PCI-SIG ENGINEERING CHANGE NOTICE

TITLE:	Precision Time Measurement (PTM), Revision 1.0a
DATE:	Updated: 31 March 2013 (errata fix)
AFFECTED DOCUMENT:	PCI Express Base Specification v3.0, PCI Code and ID Assignment Specification v1.3
SPONSOR:	Intel, HP

Figure 2-xi: PTM Request/Response Message

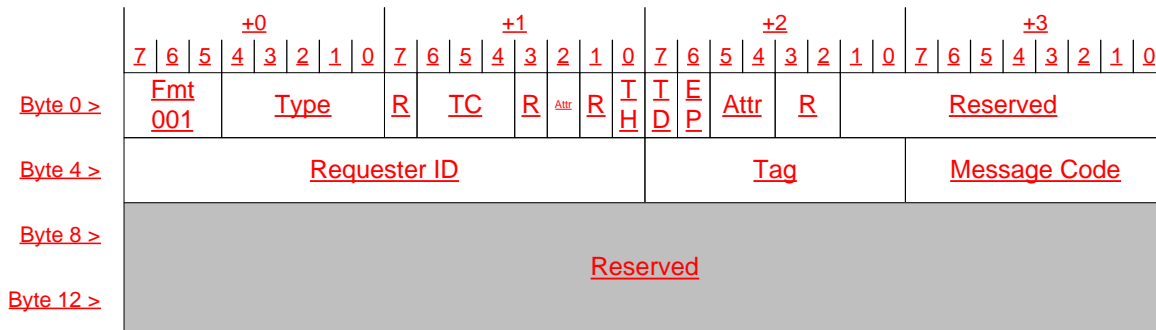
The PTM Request and PTM Response Messages must use a TLP Type of Msg, and must not include a data payload. The Length field is reserved.

- Figure 2-xi illustrates the format of the PTM Request and Response Messages.

Figure 2-xii: PTM ResponseD Message (4 DW header and 1 DW payload)

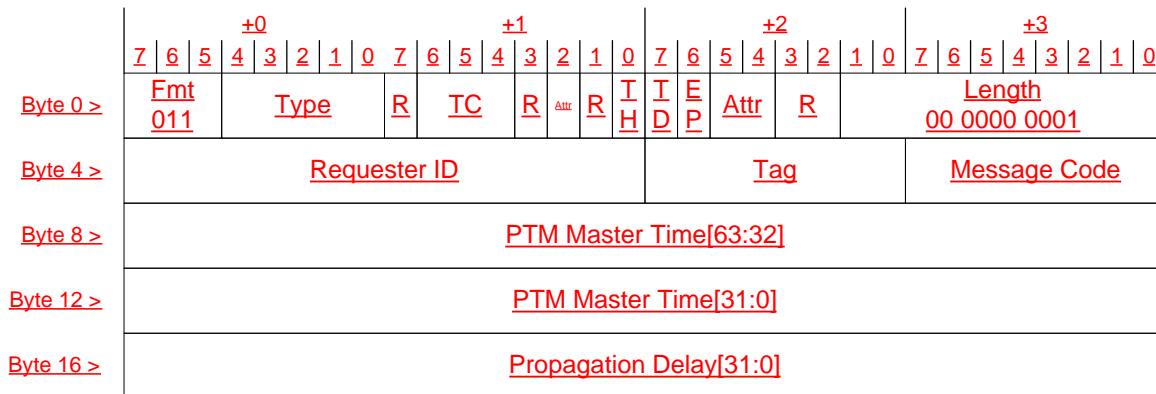
The PTM ResponseD Message must use a TLP Type of MsgD, and must include a 64 bit PTM Master Time field in bytes 8 through 15 of the TLP header and a 1 DW data payload containing the 32 bit Propagation Delay field.

- Figure 2-xii illustrates the format of the PTM ResponseD Message.

Figure 6-b: Precision Time Measurement Link Protocol

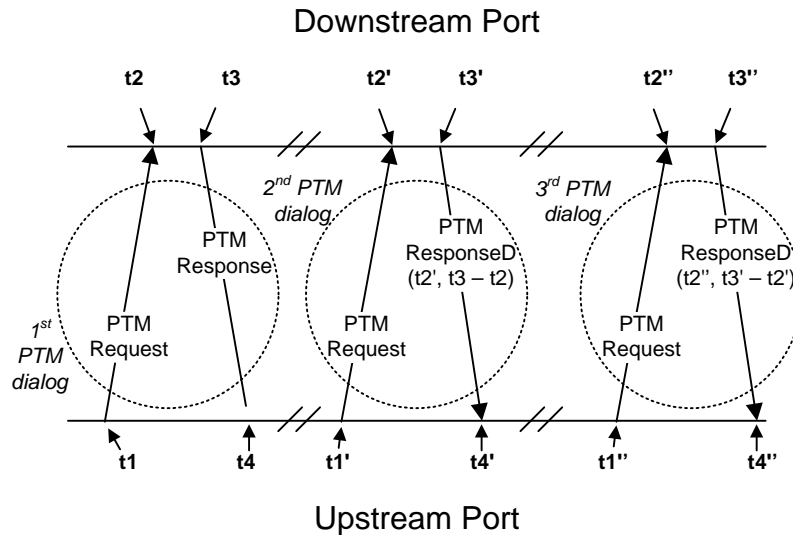
Figure 6-b illustrates the PTM link protocol. The points t1, t2, t3, and t4 in the above diagram represent timestamps captured locally by each Port as they transmit and receive PTM Messages. The component associated with each Port stores these timestamps from the 1st PTM dialog in internal registers for use in the 2nd PTM dialog, and so on for subsequent PTM dialogs.

Referring to Figure 6-b, the following rules define timestamp capture:

- A PTM Requester must update its stored t1 timestamp when transmitting a PTM Request Message, even if that transmission is a replay.
- A PTM Responder must update its stored t2 timestamp when receiving a PTM Request Message, even if received TLP is a duplicate.

- A PTM Responder must update its stored t3 timestamp when transmitting a PTM Response or ResponseD Message, even if that transmission is a replay.
- A PTM Requester must update its stored t4 timestamp when receiving a PTM Response Message, even if received TLP is a duplicate.

- The PTM Master Time field is a 64-bit value containing the value of PTM Master Time at the receipt of the PTM Request Message for the current PTM Dialog. In Figure 6-b, for the 2nd PTM dialog, this is the PTM Master Time at time t2'.

- The Propagation Delay field is a 32-bit value containing the interval between the receipt of the PTM Request Message and the transmission of the PTM Response Message for the previous PTM dialog. In Figure 6-b, for the 2nd PTM dialog, this is the time interval between t2 and t3 captured during the 1st PTM dialog.

Figure 6-d: PTM Requester Operation

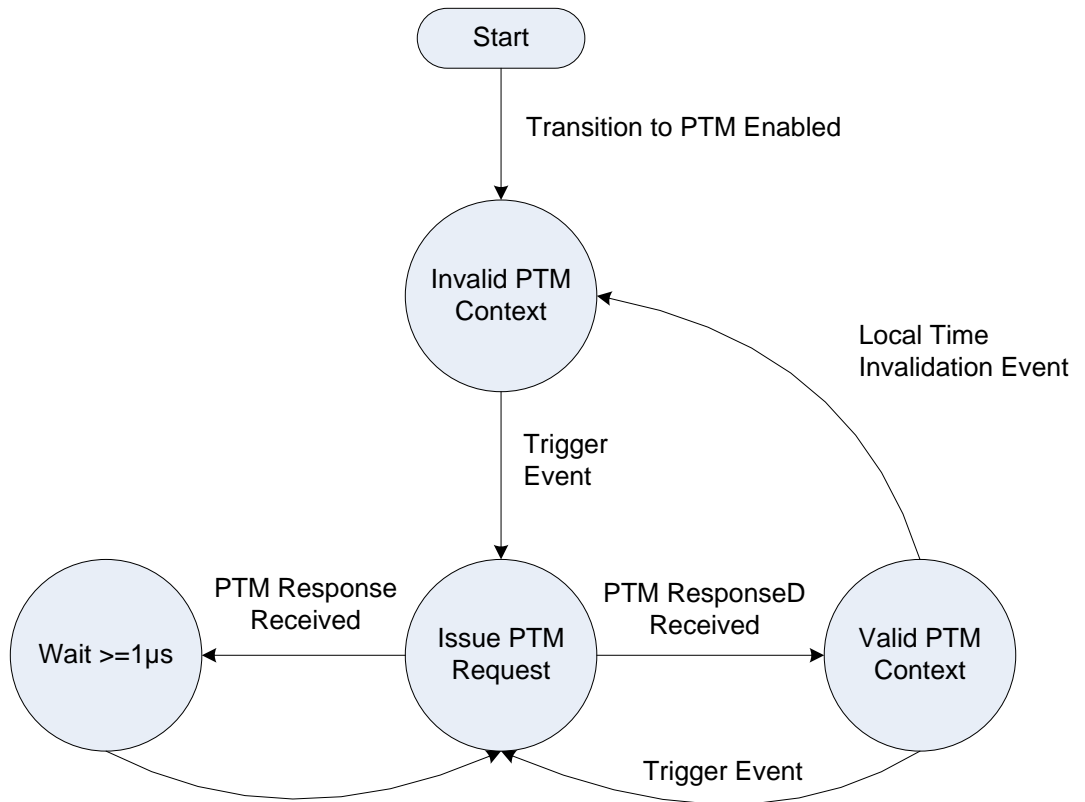
- ❑ It is strongly recommended that an Upstream Port invalidate its internal PTM context when the relationship between PTM Master Time and the Upstream Port's local time changes, as determined by implementation specific criteria. For example, this may occur as a result of a transition to a non-D0 state or due to accumulated PPM drift. These events are grouped under the label "Local Time Invalidation Event" in Figure 6-d.

Figure 7-c: PTM Capability Register

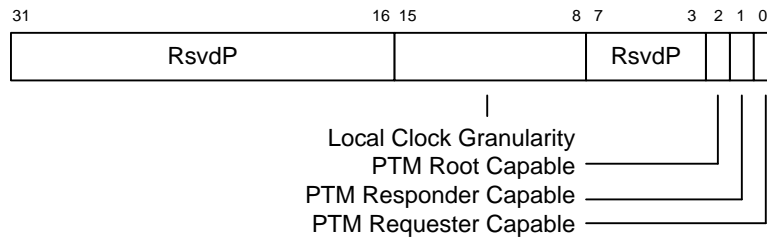
<u>Bit Location</u>	<u>Register Description</u>	<u>Attributes</u>
<u>0</u>	<u>PTM Requester Capable</u> – Endpoints and Root Complex Integrated Endpoints are permitted to, and Switches supporting PTM must, set this bit to 1b to indicate they implement the PTM Requester role (see Section 6.x.2.1).	<u>HwInit</u>
<u>1</u>	<u>PTM Responder Capable</u> – Root Ports and RCRB's are permitted to, and Switches supporting PTM must, set this bit to 1b to indicate they implement the PTM Responder role (see Section 6.x.2.2). If PTM Root Capable is Set, this bit must be Set to 1b.	<u>HwInit</u>
<u>2</u>	<u>PTM Root Capable</u> – Root Ports, RCRB's and Switches are permitted to set this bit to 1b, if they implement a PTM Time Source Role and are capable of serving as the PTM Root.	<u>HwInit</u>
<u>7:3</u>	<u>Reserved</u>	<u>RsvdP</u>
<u>15:8</u>	<u>Local Clock Granularity</u> – <u>0000 0000b</u> – Time Source does not implement a local clock. It simply propagates timing information obtained from further Upstream in the PTM Hierarchy when responding to PTM Request messages. <u>0000 0001b</u> – <u>1111 1110b</u> : Indicates the period of this Time Source's local clock in ns. <u>1111 1111b</u> : Indicates the period of this Time Source's local clock is greater than 254 ns. If the PTM Root Select bit is Set, this local clock is used to provide PTM Master Time. Otherwise, the Time Source uses this local clock to locally track PTM Master Time received from further Upstream within a PTM Hierarchy. This field is reserved for Functions that do not implement the PTM Time Source role.	<u>HwInit/RsvdP</u>

Figure 7-d: PTM Control Register

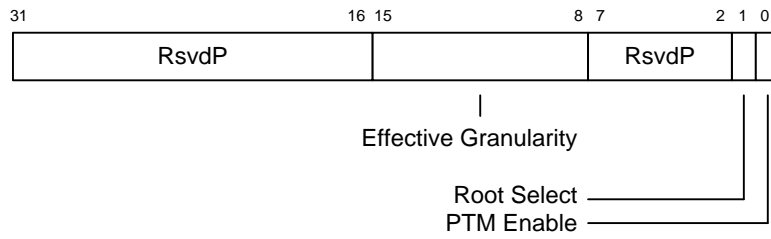
<u>Bit Location</u>	<u>Register Description</u>	<u>Attributes</u>
<u>0</u>	<p><u>PTM Enable</u> – When Set, this Function is permitted to participate in the PTM mechanism according to its selected role(s) (see Section 6.x.2).</p> <p>Default value is 0b.</p>	<u>RW</u>
<u>1</u>	<p><u>Root Select</u> – When Set, if the PTM Enable bit is also Set, this Time Source is the PTM Root.</p> <p>Within each PTM Hierarchy, it is recommended that system software select only the furthest Upstream Time Source to be the PTM Root.</p> <p>Default value is 0b.If the value of the PTM Root Capable bit is 0b, this bit is permitted to be hardwired to 0b.</p>	<u>RW/RO</u>
<u>7:2</u>	<u>Reserved</u>	<u>RsvdP</u>
<u>15:8</u>	<p><u>Effective Granularity</u> – For Functions implementing the PTM Requester Role, this field provides information relating to the expected accuracy of the PTM clock, but does not otherwise affect the PTM mechanism.</p> <p>For Endpoints, system software must program this field to the value representing the maximum Local Clock Granularity reported by the PTM Root and all intervening PTM Time Sources.</p> <p>For Root Complex Integrated Endpoints, system software must set this field to the value reported in the Local Clock Granularity field by the associated PTM Time Source.</p> <p>Permitted values:</p> <p><u>0000 0000b</u> – Unknown PTM granularity – one or more Switches between this Function and the PTM Root reported a Local Clock Granularity value of <u>0000 0000b</u>.</p> <p><u>0000 0001b</u> – <u>1111 1110b</u> – Indicates the effective PTM granularity in ns.</p> <p><u>1111 1111b</u>: Indicates the effective PTM granularity is greater than 254 ns.</p> <p>Default value is <u>00000b</u>. If PTM Requester Capable is Clear, this field is permitted to be hardwired to <u>0000 0000b</u>.</p>	<u>RW/RO</u>
